Request Summary

- **Design Review**
 - Reconfigure drive thru and landscaping at existing Starbucks
 - Removal of some concrete, landscaping, three trees, and 14 parking spaces
 - Two new trees and one new island proposed
 - Relocation of existing menu board and associated equipment
 - Signage will be reviewed through permitting process
 - Drive thru will have 11 stacking spaces for cars
 - New island separating drive thru lane and parking and new curb separating drive thru from adjacent lot

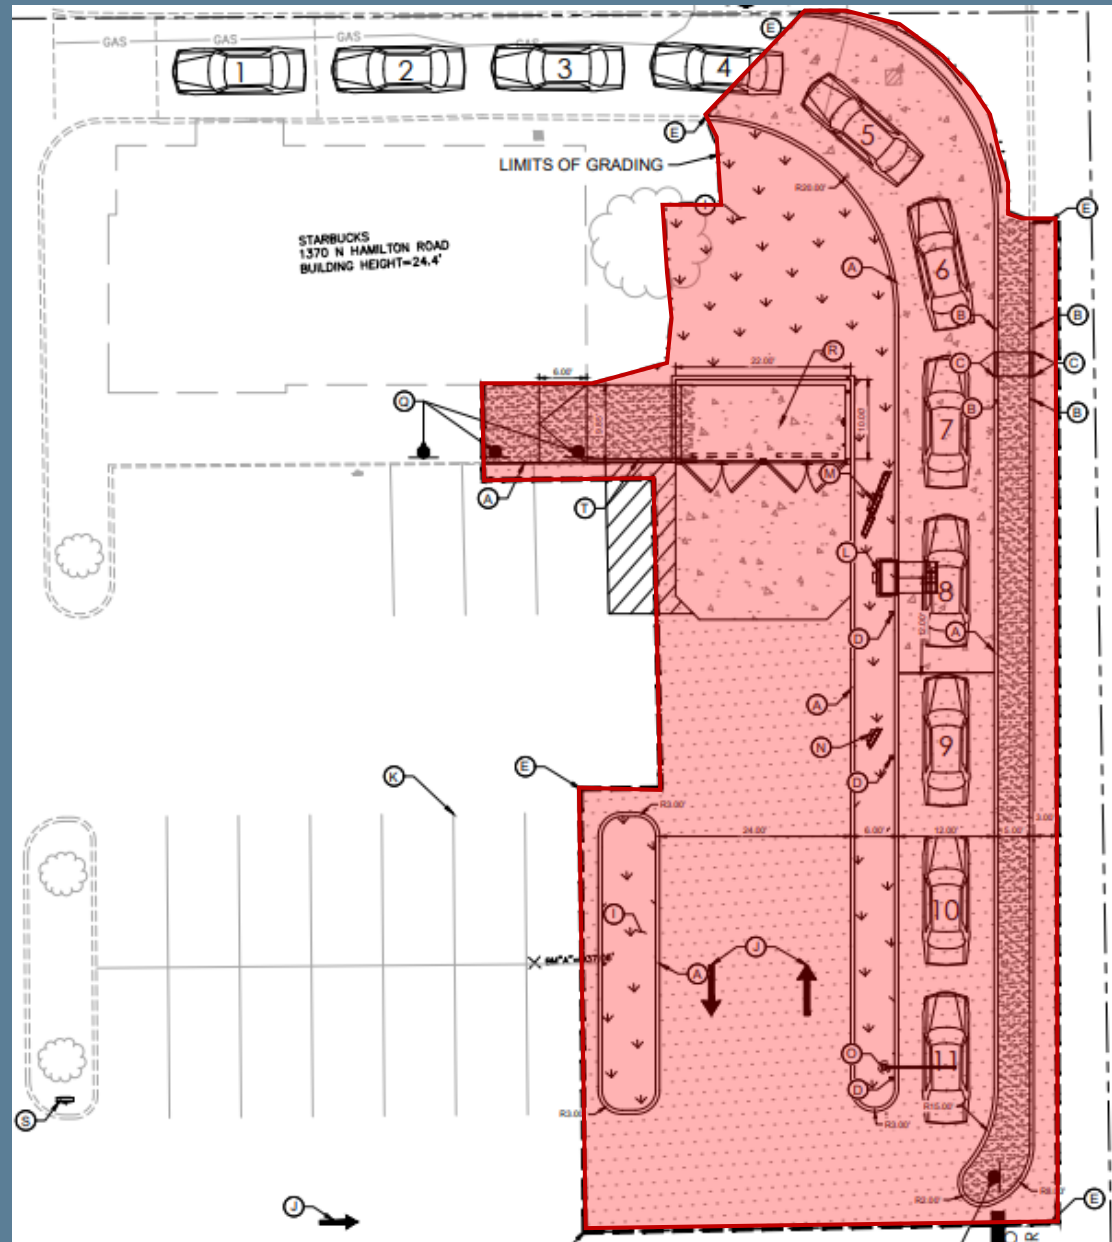
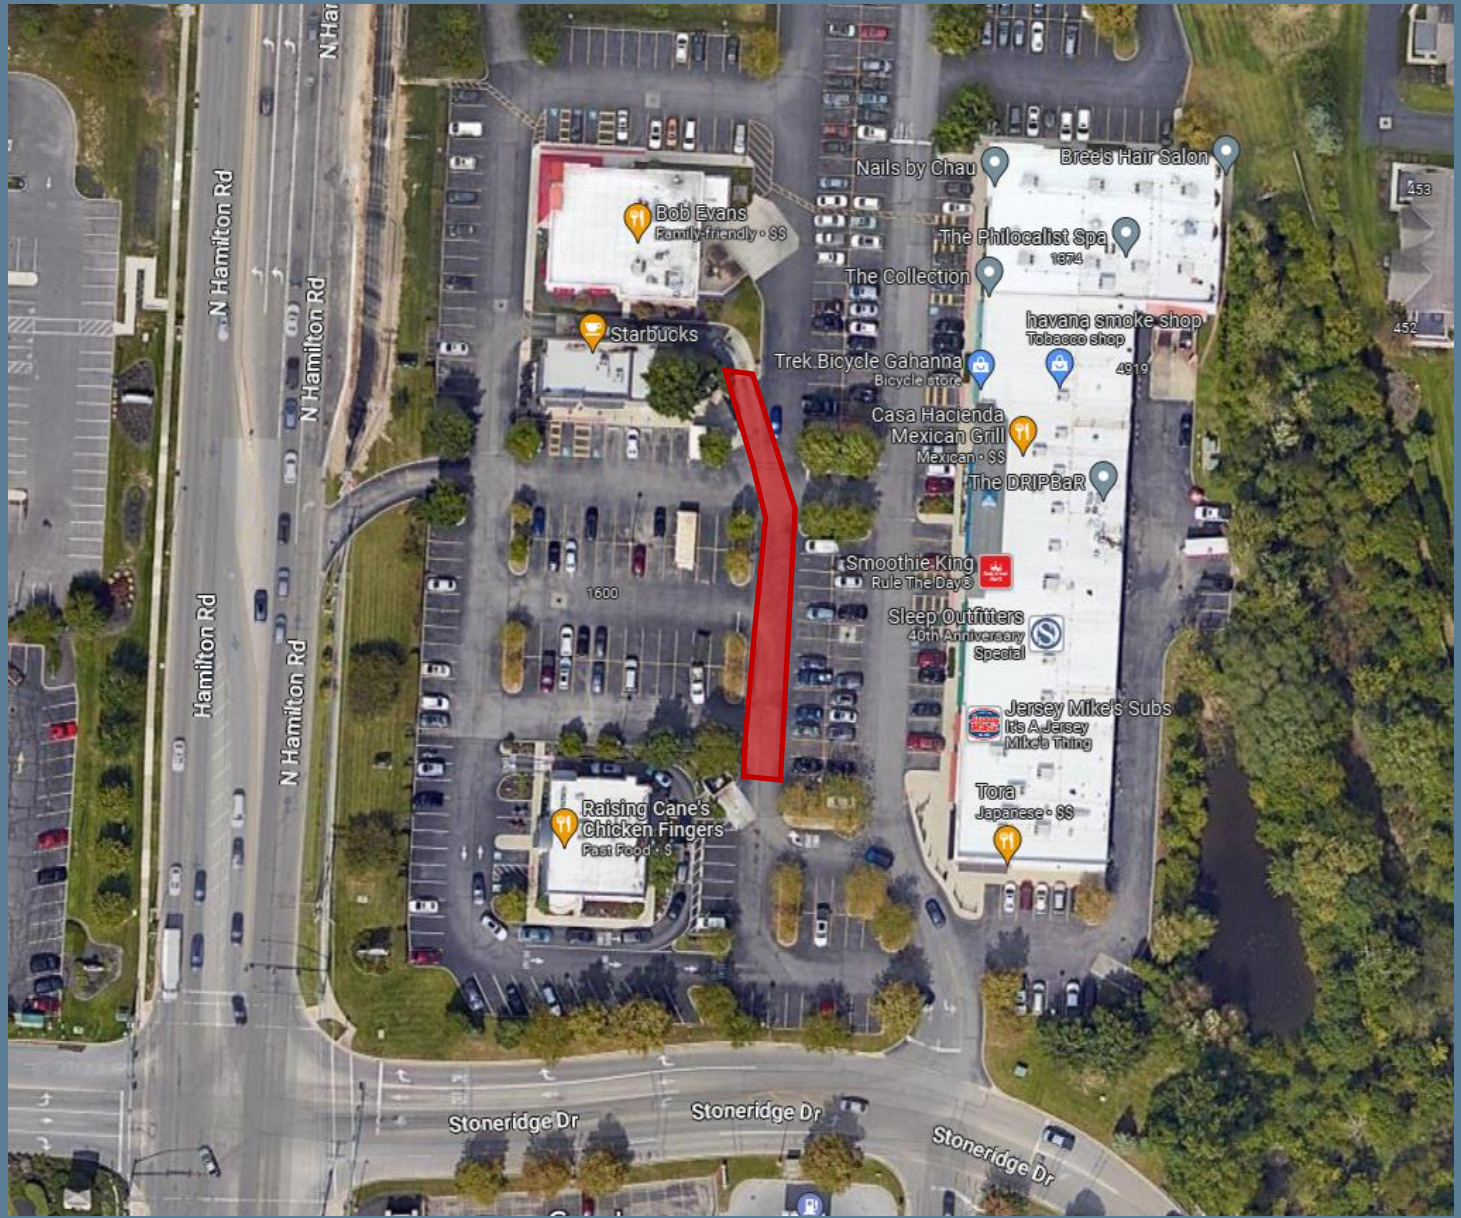
- Staff recommendation
 - Approval
 - All criteria met
 - Site will align more with DRD-3 with modifications
 - No changes to existing building
 - Help relieve circulation issues
